## [Darshan\\_04\\_0917.pdf](#) (PSE state machine Part A- Using CLASS\_PROBE in Figure 145-15/16)

*Comment (i-198, i-269, i-406)*

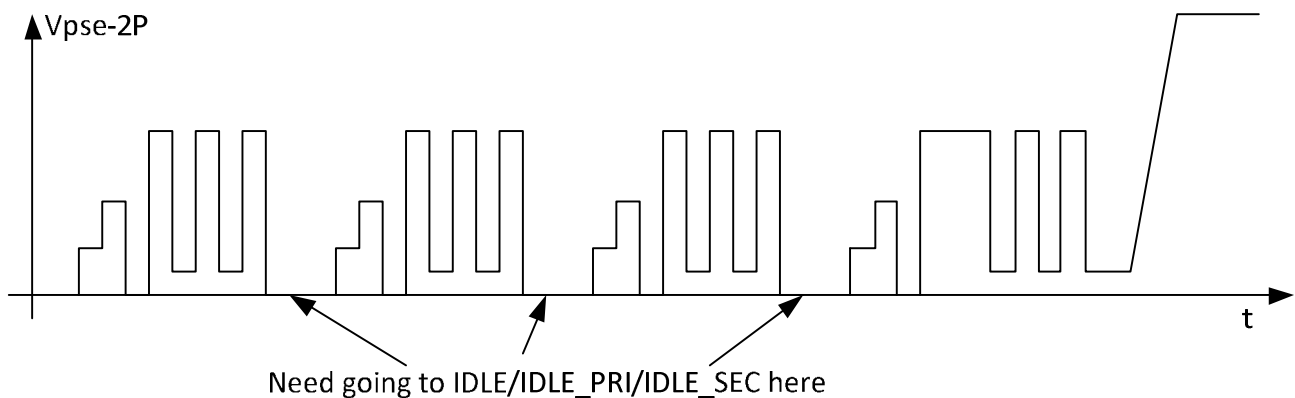
Some PSE architectures are generating sequences of detection + classification events and waiting for the host to decide when to power on the port. This requires the class probe functionality and exit to IDLE in the classification state machines (for single-signature and dual-signature). Single-signature has global pse\_reset input to IDLE so in this case, PSE can go to IDLE at any time. It is not the case in dual-signature.

As a result, we need to:

- (1) Add CLASS\_PROBE\_PRI/SEC functionality for primary and secondary.
- (2) Add global exit to IDLE\_PRI/SEC by using pse\_reset\_pri/sec by changing the input to IDLE\_PRI to  $\text{sism}*(\text{iclass\_lim\_det\_pri}+\text{pse\_reset\_pri})$  it will do two things: pse\_reset\_pri and multi-true issue with IDLE\_PRI and ENTRY\_PRI. To implement same changes for secondary.

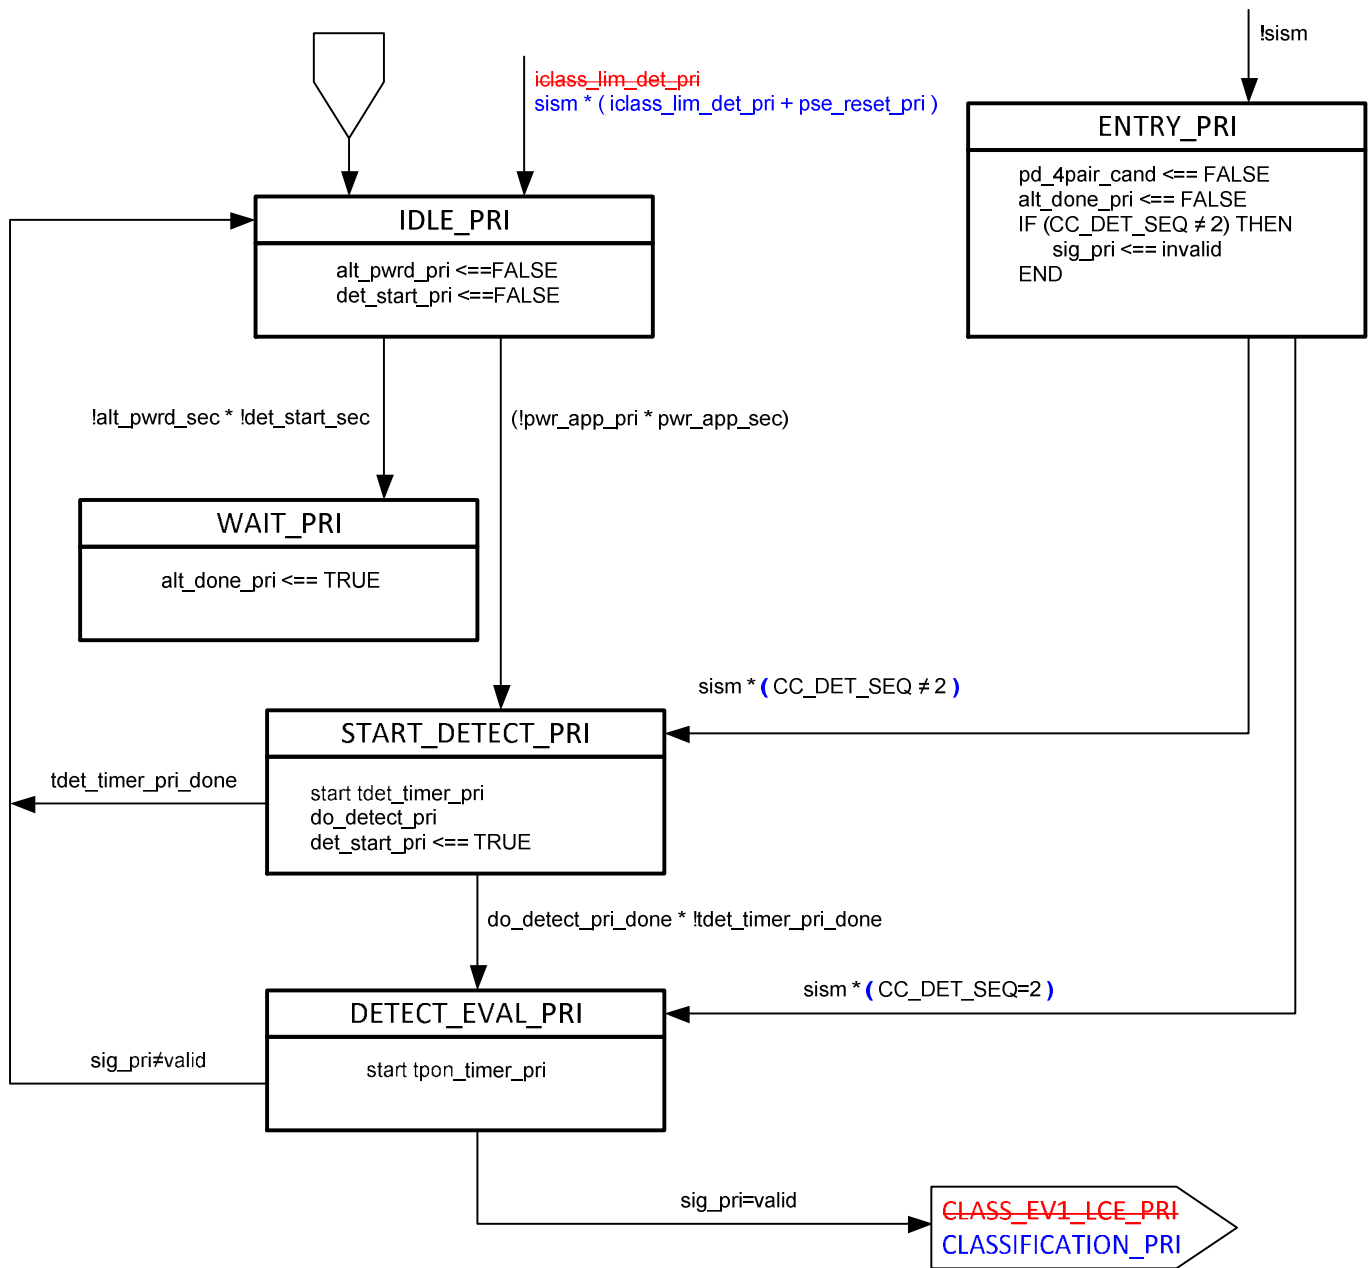
3. Make the following changes to the state machine in page 132

Figure 145-15—Primary Alternative dual-signature semi-independent PSE state diagram (continued)

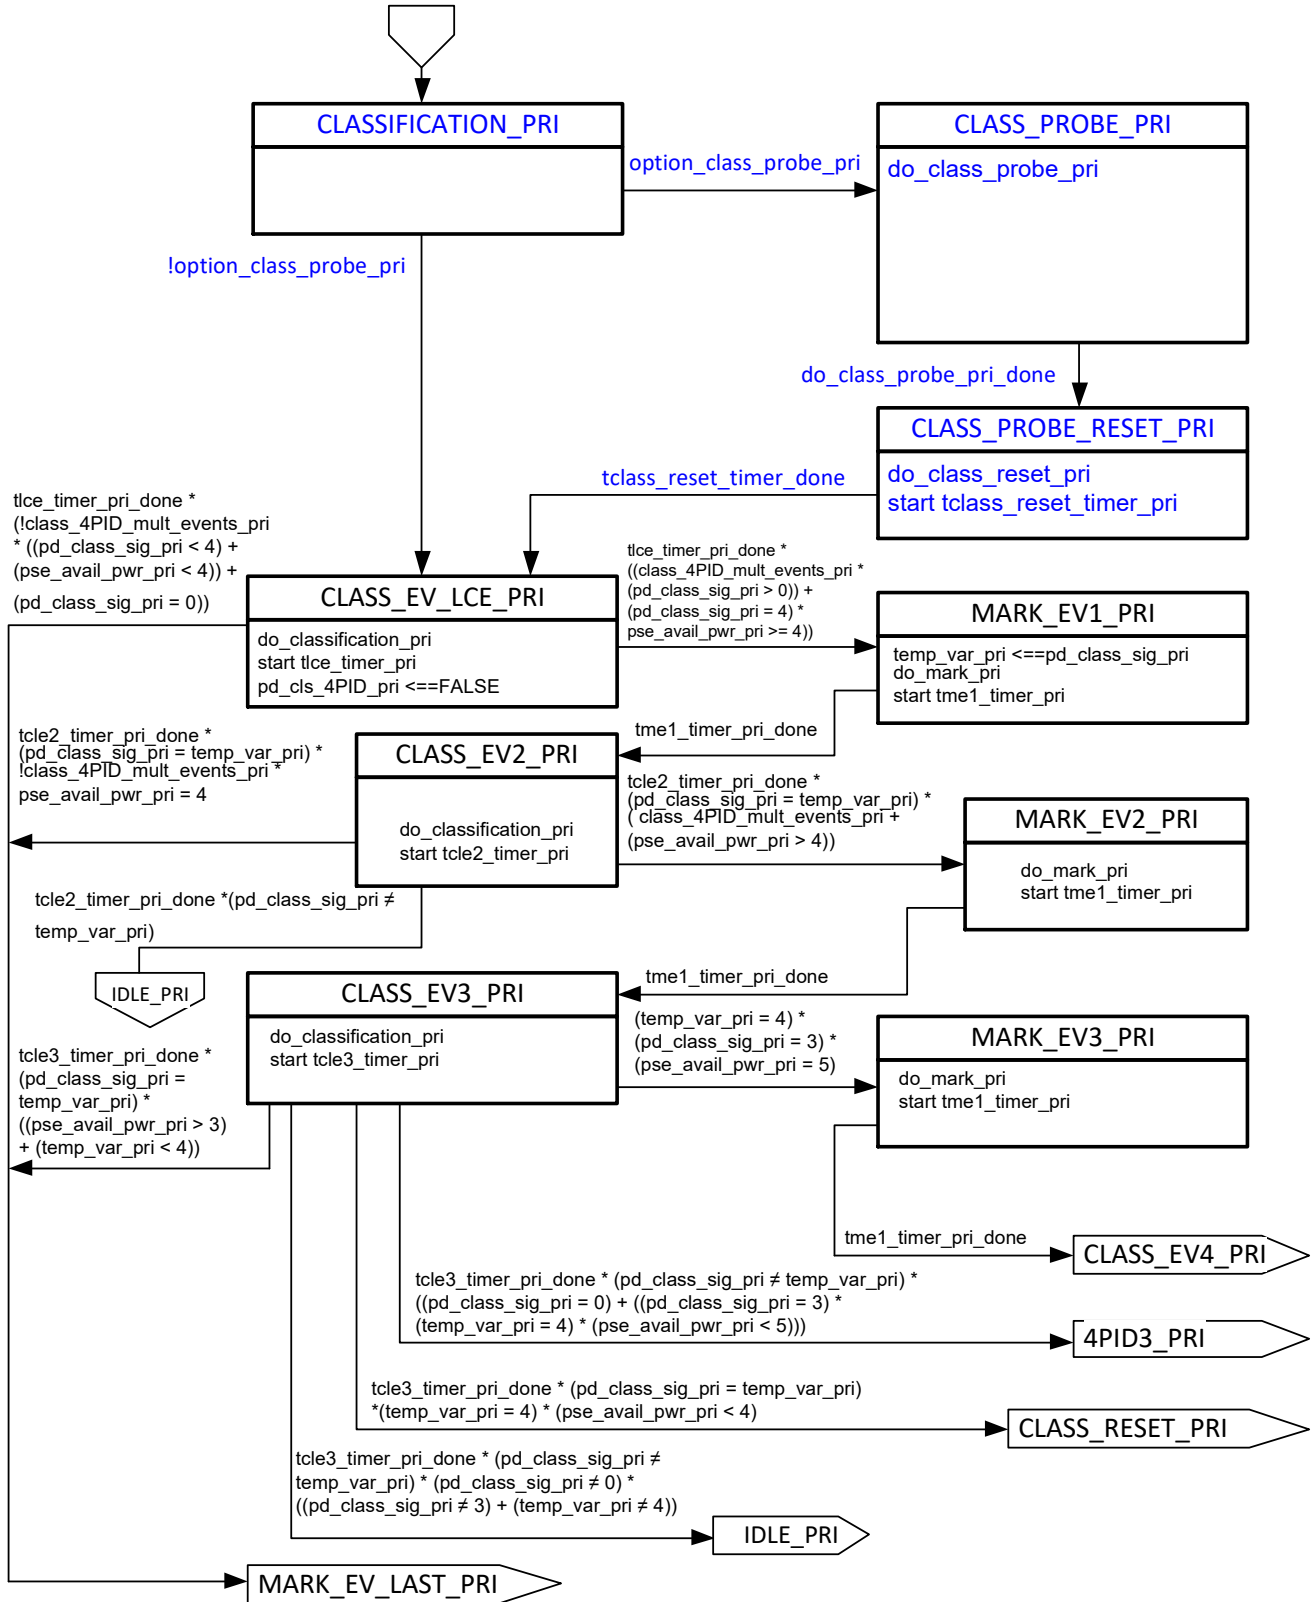
4. Make the following changes to Figure 145-15 page 133

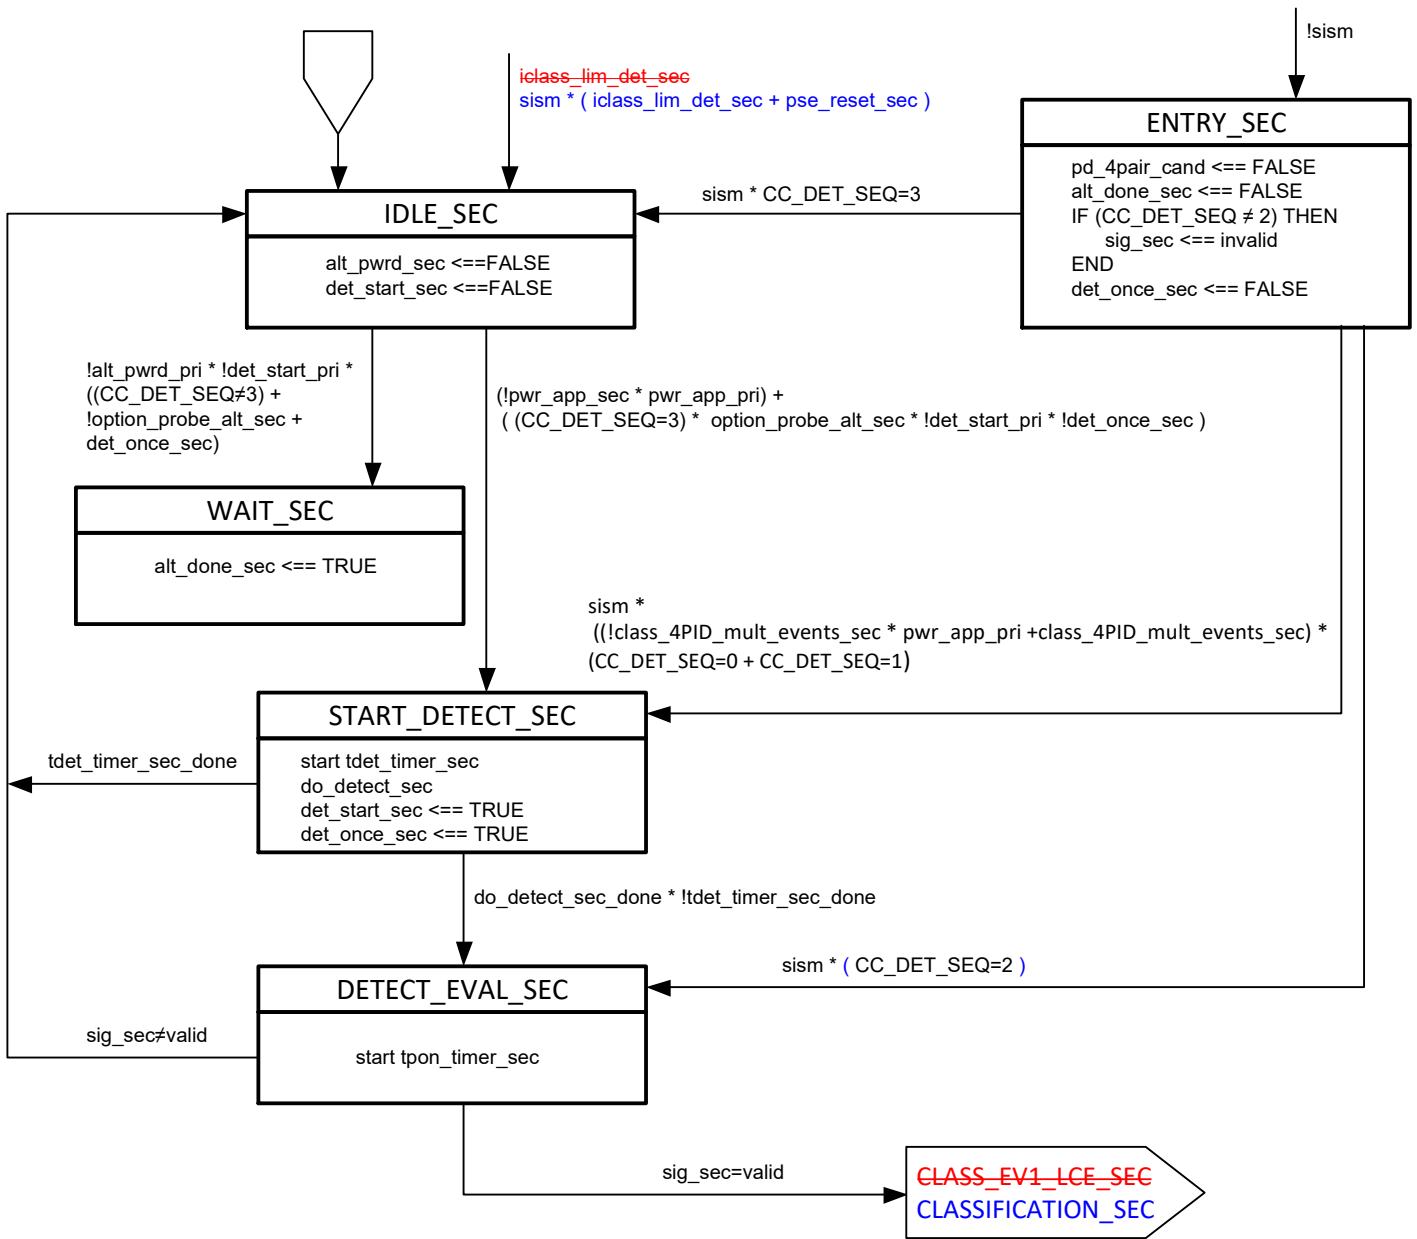
5. Make the following changes to the state machine in page 136

Figure 145-15—Primary Alternative dual-signature semi-independent PSE state diagram (continued)

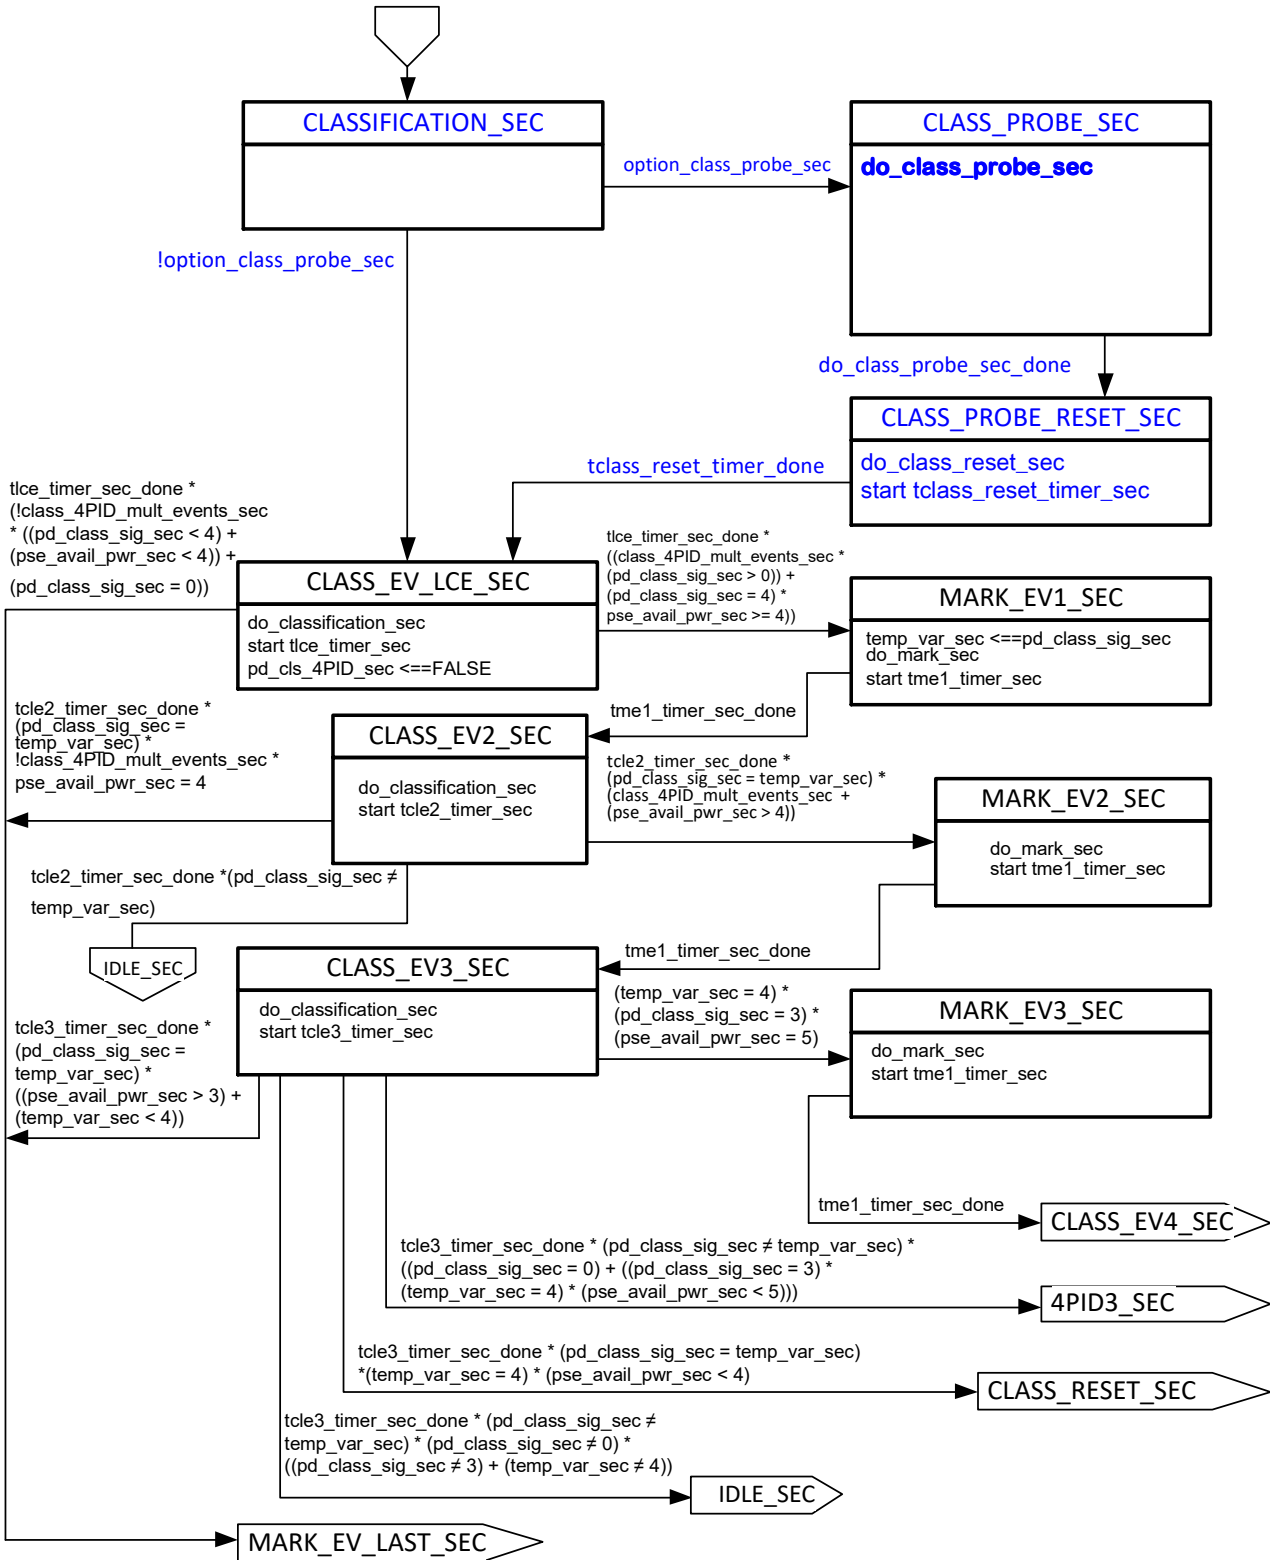
6. Make the following changes to Figure 145-15 pages 137
